16-11166

### Manual Amendment

These changes apply to Touchmaster Infinity manual 16-60068.2-101. In some cases part numbers have changed or were in error. In other cases, part descriptions do not appear in existing manual at all.

## CPU BOARD ASSEMBLY (A-23341)

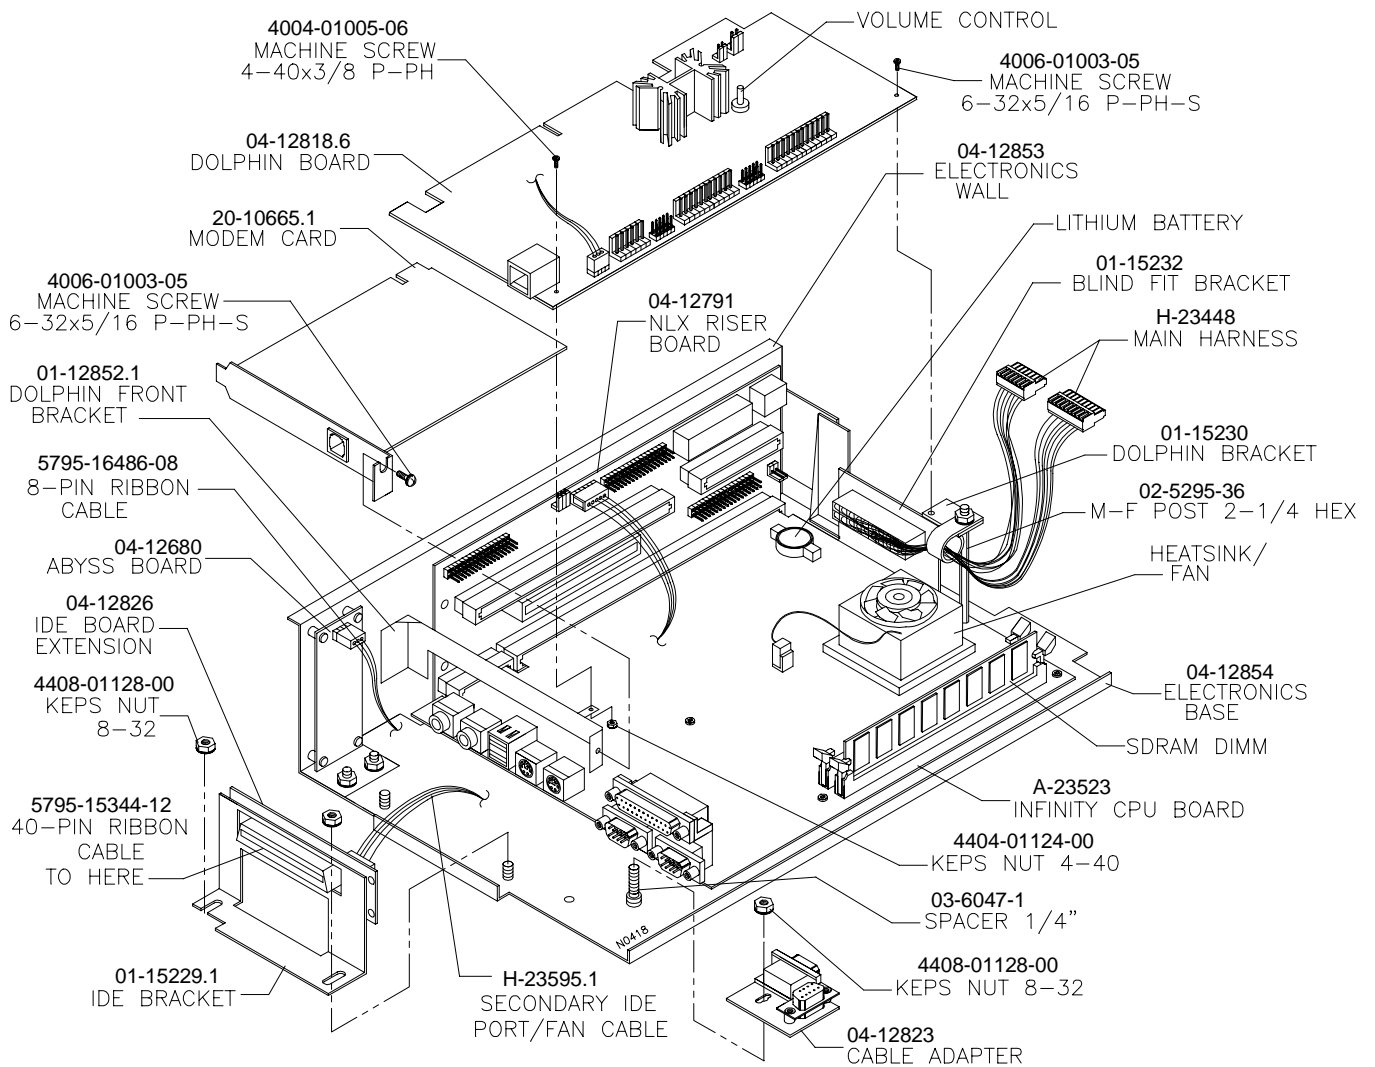
Page No.	Part Description	Correct Part Number
Service - 9	Touchscreen Replacement	See enclosed sheet 16-11151
Parts - 2	Cabinet Assembly (Rear View) There are two Machine Screws 4-40x3/8 P-FH to hold line filter.	4004-01041-06
Parts - 4	HD Bracket Assembly	A-23343
Parts - 5	Marquee Artwork on Top Cover	31-3630
Parts - 6	Monitor-Touchscreen Assembly	See enclosed sheet 16-11151
Parts - 6	Foam Pad on Base Assembly	23-6821.1
Parts - 7	Coin Door Support Bracket	04-12723.1
Parts - 8	CPU Board Assembly	See illustration on other side
